MONITORING YEAR 2 ANNUAL REPORT

BUG HEADWATERS MITIGATION SITE

Subject: Draft MY2 Report Review
Bug Headwaters Mitigation Site, Wilkes County
Yadkin River Basin: 03040101
DMS Project ID No. 100084
DEQ Contract #7617

CROSS-SECTION PLOTS

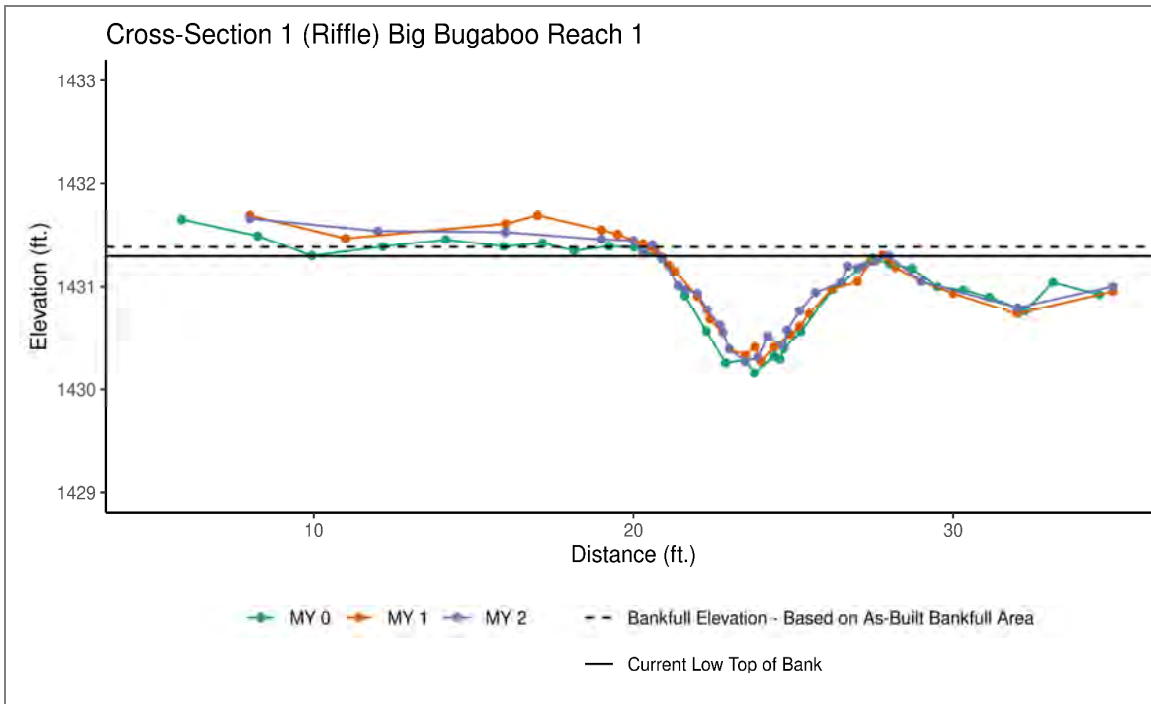
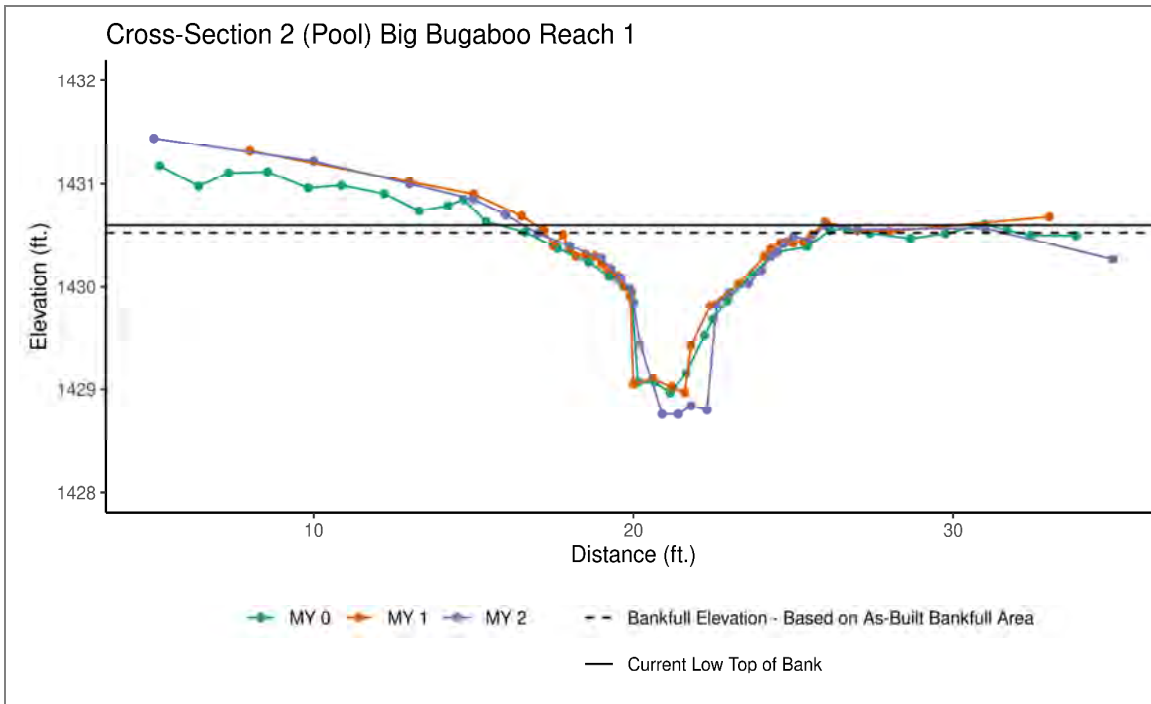
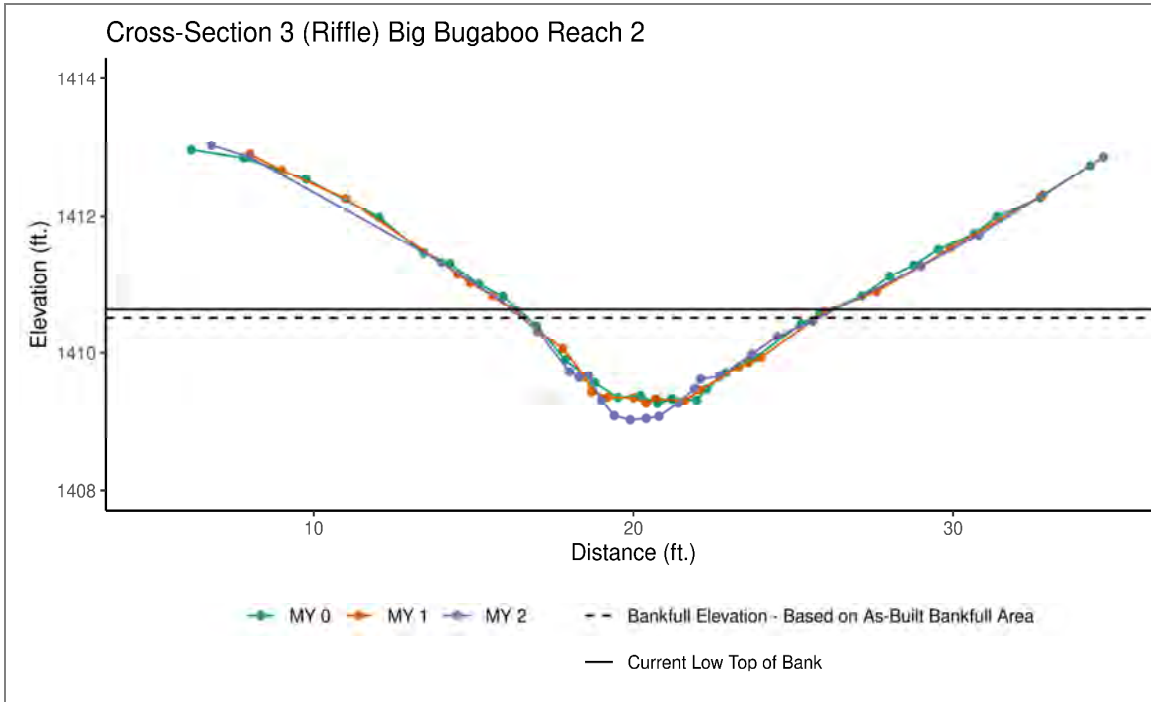
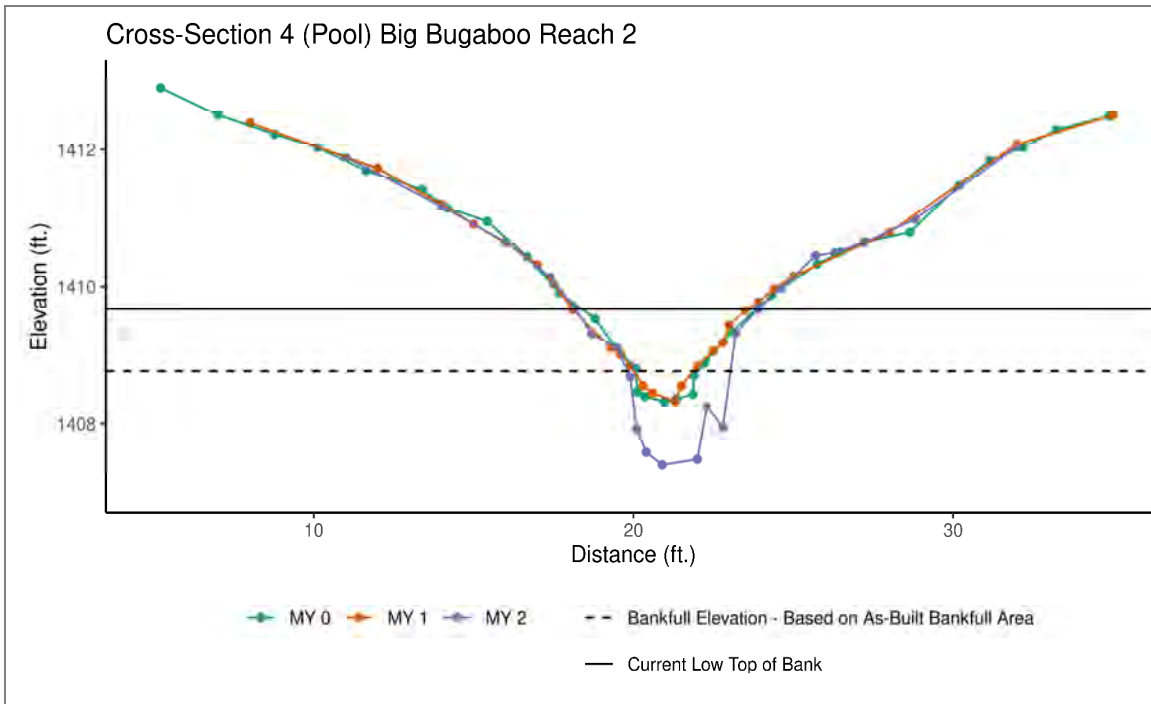
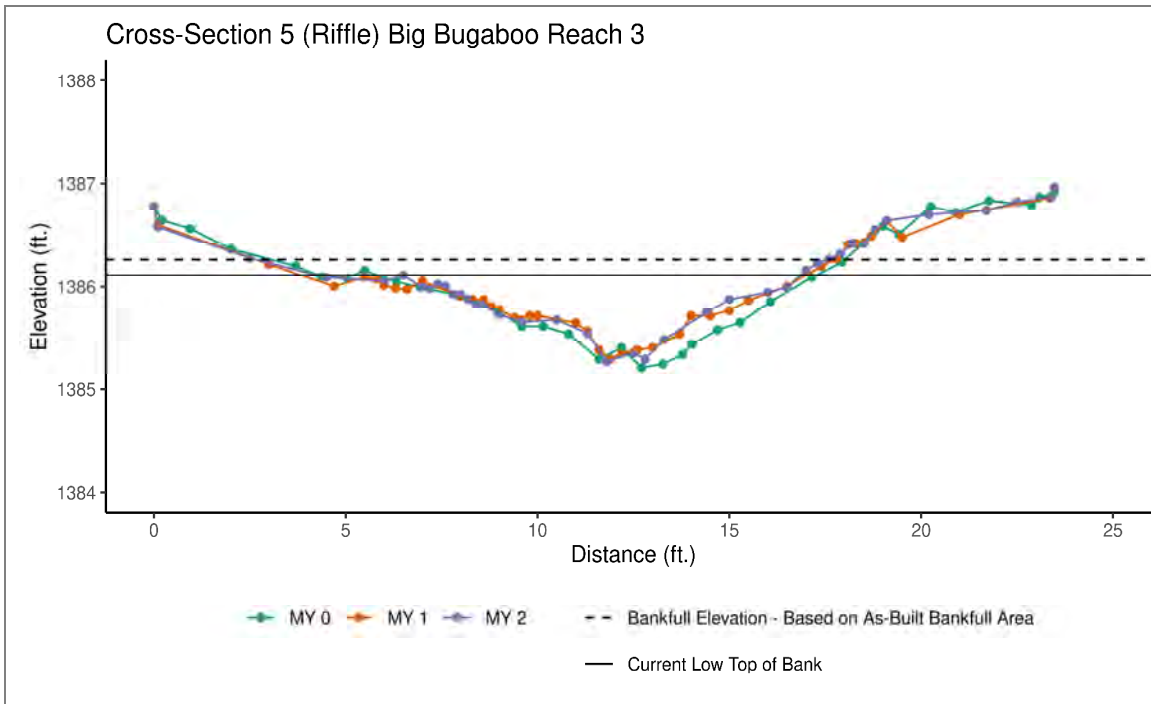
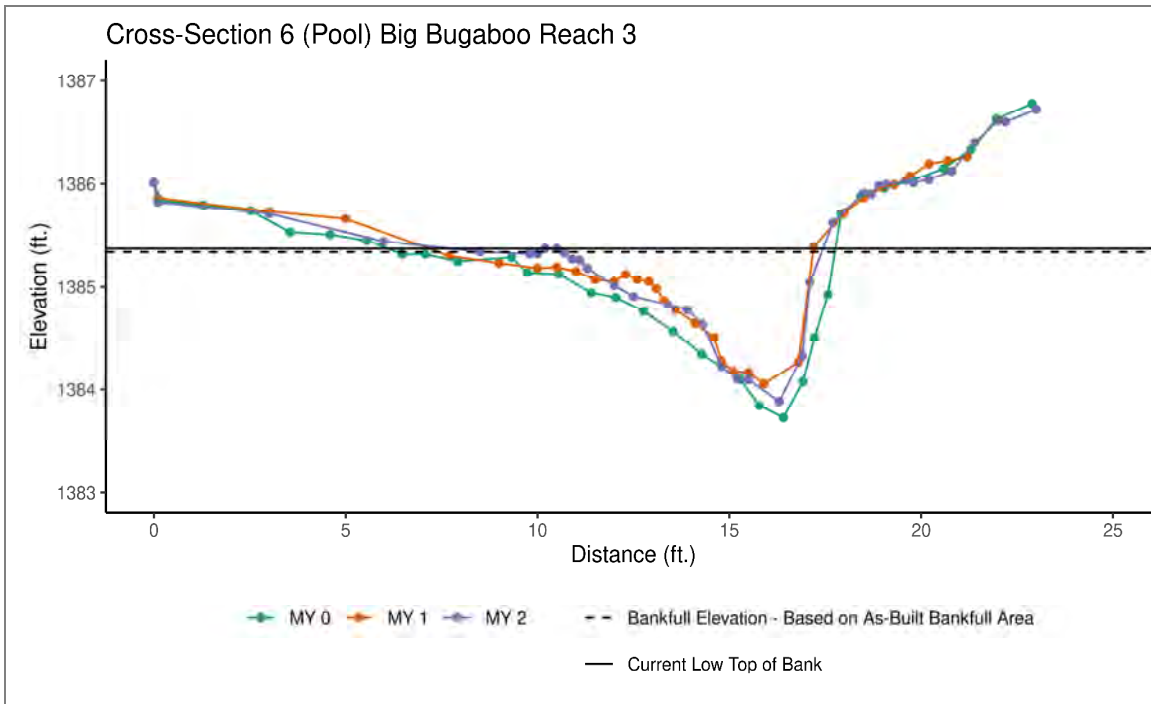
Cross-Section Plots: Majority of cross-section plots do not start and stop on same points. The 2016 IRT Mitigation Update specifies that cross sections be permanent. Are permanent cross sections (concrete, rebar, etc.) installed on the site? Are cross sections manually adjusted for overlays?

Cross-Section Plots: Please turn off the line markers for MY0 and MY1 sections.

Response: Permanent cross-sections are installed across the Site with concrete and rebar marking them. However, based on previous IRT comments wanting consistent X axis across reaches, Wildlands set up the X and Y axis at consistent intervals that zoom into the cross-section to an appropriate extent. While trying to maintain consistent intervals, the end rebar may not be shown in the plot but is shown in the raw data.

Response: Due to the limited user functionality Wildlands has with Shiny Apps, Wildlands does not have a way to turn off the line markers for MY0 and MY1 sections.
